FOR PLANNING

This document shows the differences between the superceded site plan and the new site plan. It is to be read in conjunction with all other submitted documents.

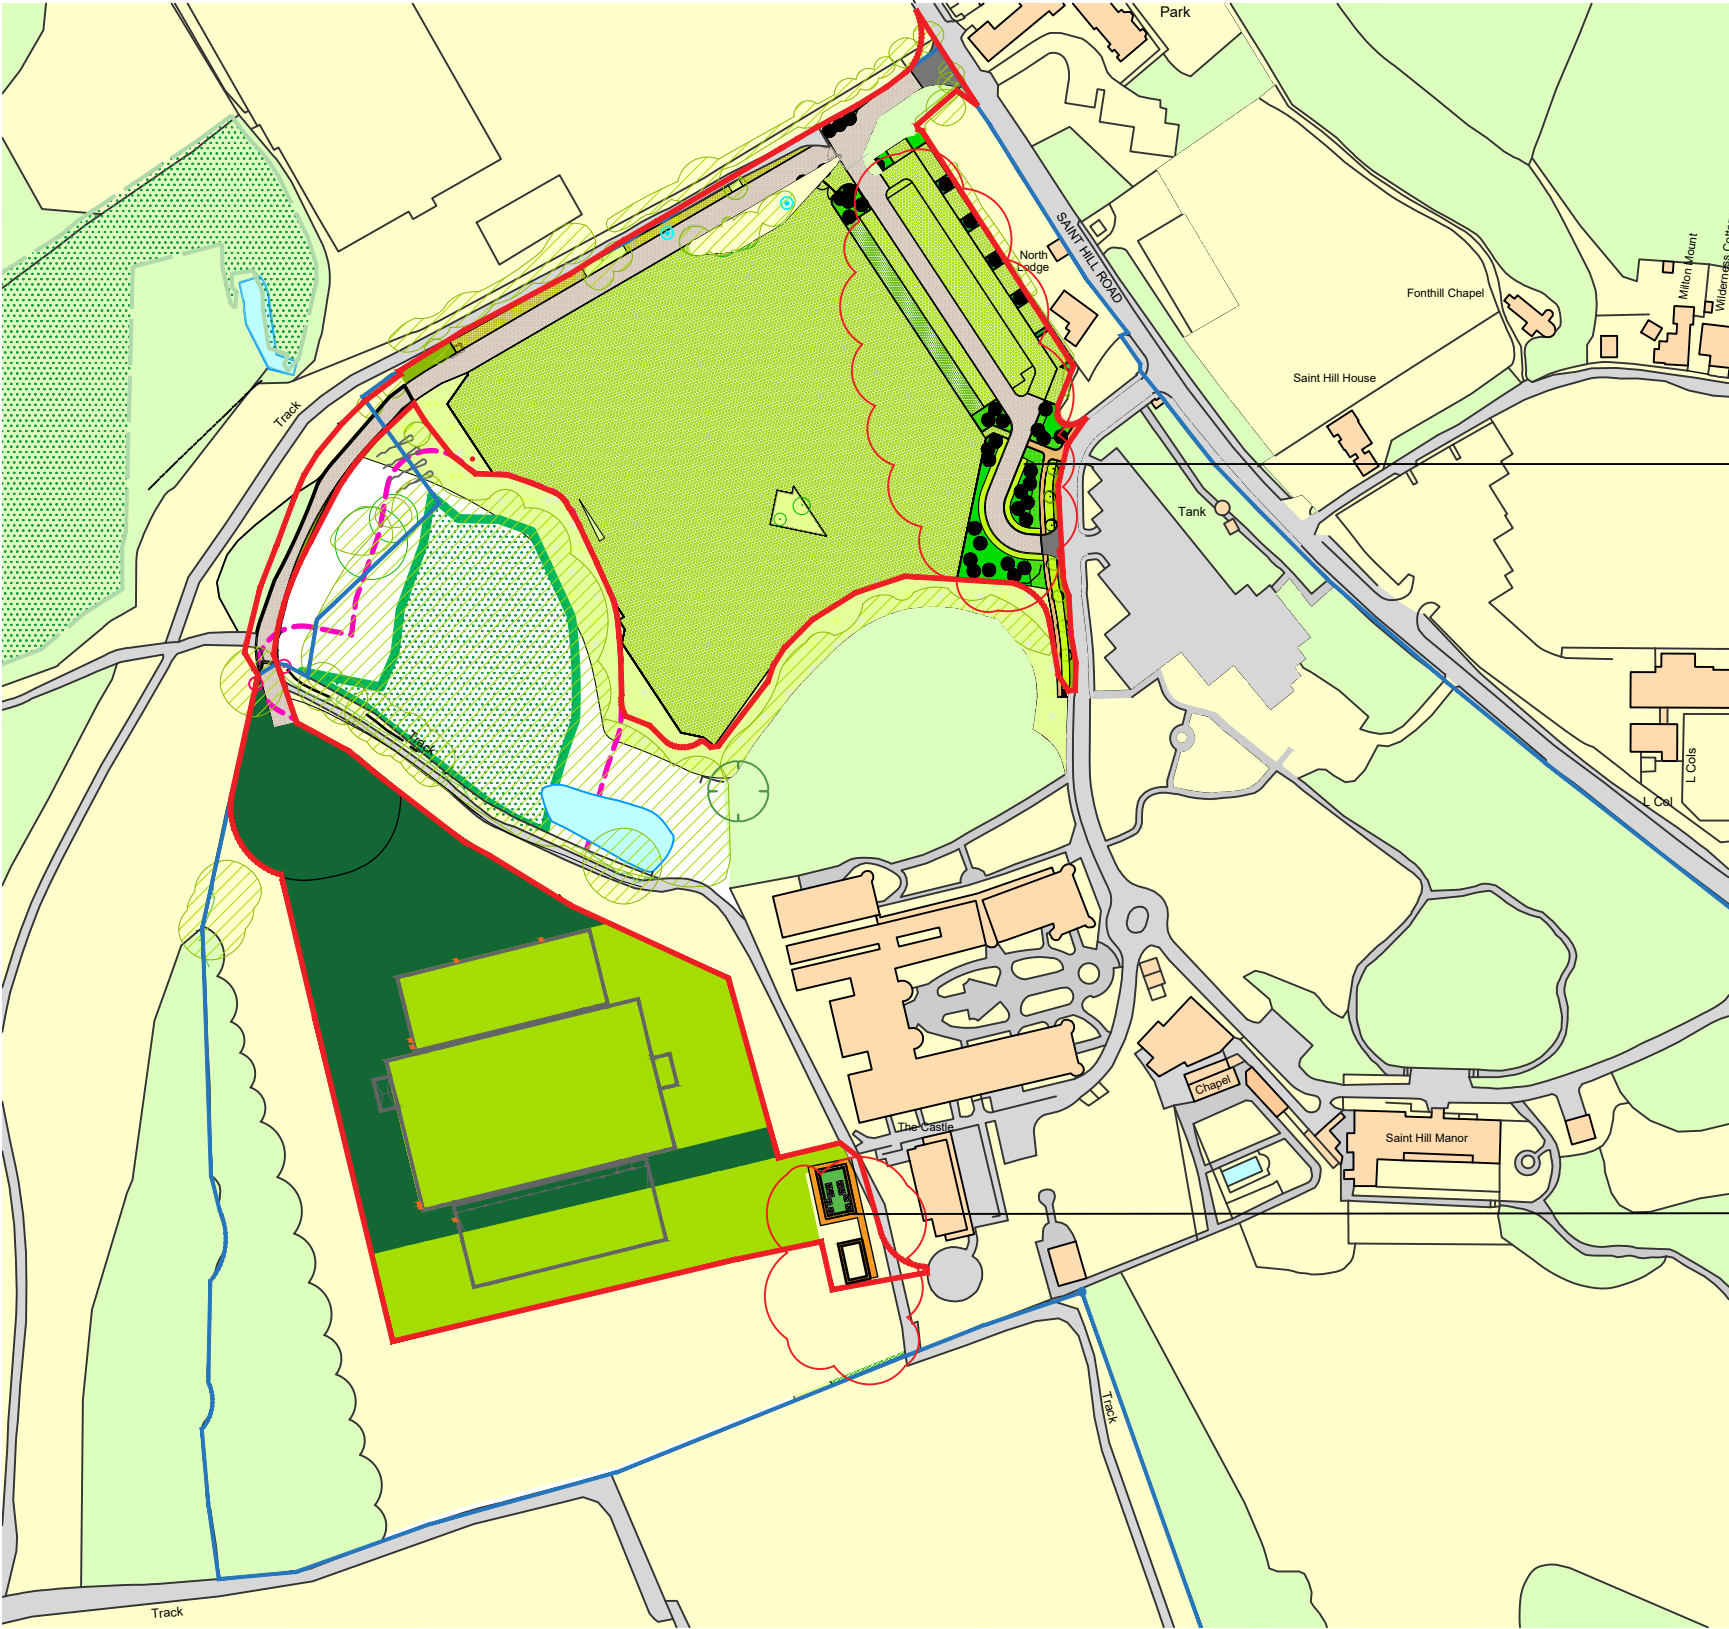
Entrance to car park has been modified to reduce visual impact to Saint Hill Road

Waiting area shelter removed

Previously proposed tarmac surfaced car park has been replaced with reinforcement grid surface. The majority of this surface is grass filled. There is a strip of gravel filled reinforcement grid between the two accesses to the proposal.

Number of proposed trees has been reduced to improve the open field character.

Washroom adjacent to refectory has been reduced in size and is surrounded by BNG enhancement reducing visual impact of this development. The washroom now features masonry stone external structure.
